Appendix E
Data Requests and Responses

Energy Environmental Review And Analysis
Questions for Development of Environmental Review

In the Matter of the Application of Walleye Wind, LLC for a Certificate of Need for the Walleye Wind Project
and Associated Facilities in Rock County

PUC Docket No.	IP7026/CN-20-269	Directed To:	Brian Murphy
EERA Question No.	1	Please Respond By:	March 3, 2021

MAP 15 - LAND OWNERSHIP
 WALLEYE WIND PROJECT
 WALLEYE WIND, LLC
 ROCK COUNTY, MINNESOTA
 DATE: 03/18/2021

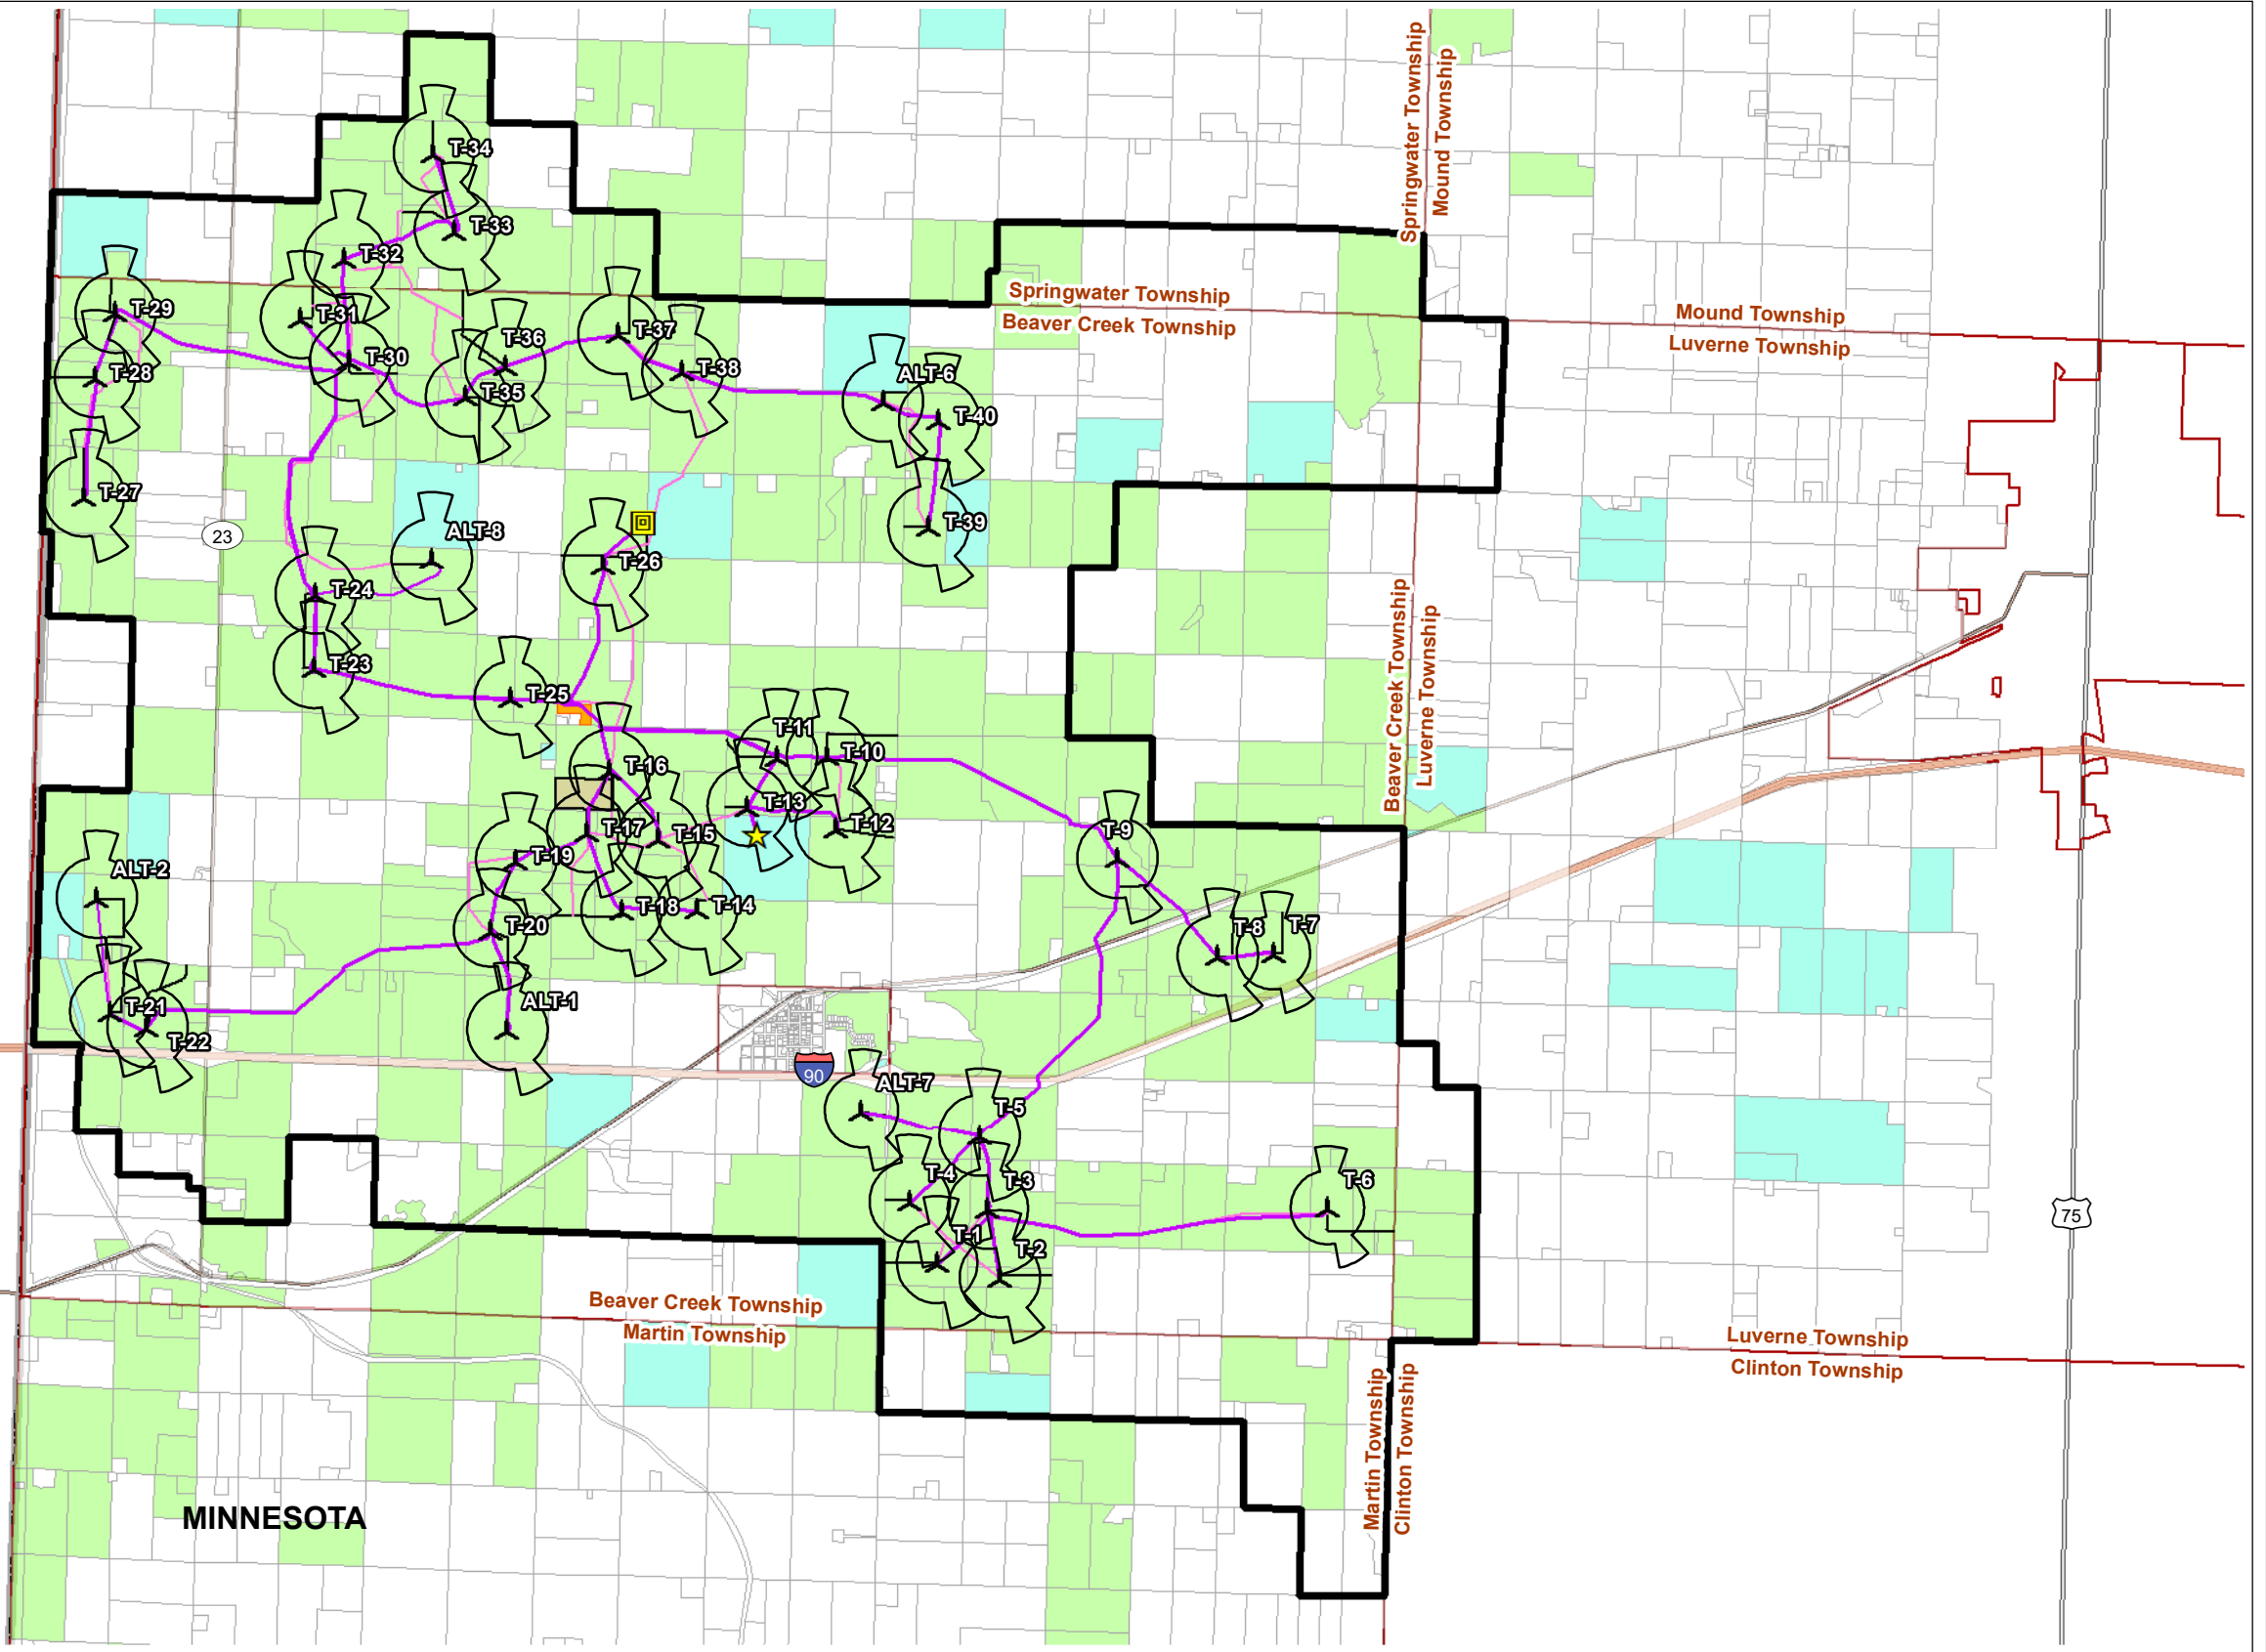
Please provide Walleye Wind's current land rights status updating Walleye Wind's December 21, 2020, letter summarizing interconnection and land rights status.

As of March 19, 2021, Walleye Wind, LLC (Walleye Wind) has substantially completed securing landowner agreements for wind rights and property easements necessary to support the Walleye Wind Project (Project). The overall area within the Site consists of approximately 31,095 acres (49 square miles). As of March 19, 2021, Walleye Wind has executed and recorded landowner agreements for approximately 14,448 acres within the Site, which is approximately 92% of the land required to complete the Project. Leased parcels are shown on the attached Map 15 (Land Ownership). Walleye Wind remains in negotiation with a number of landowners within the Site and anticipates acreage being added to the Project's leased lands no later than April 30, 2021.
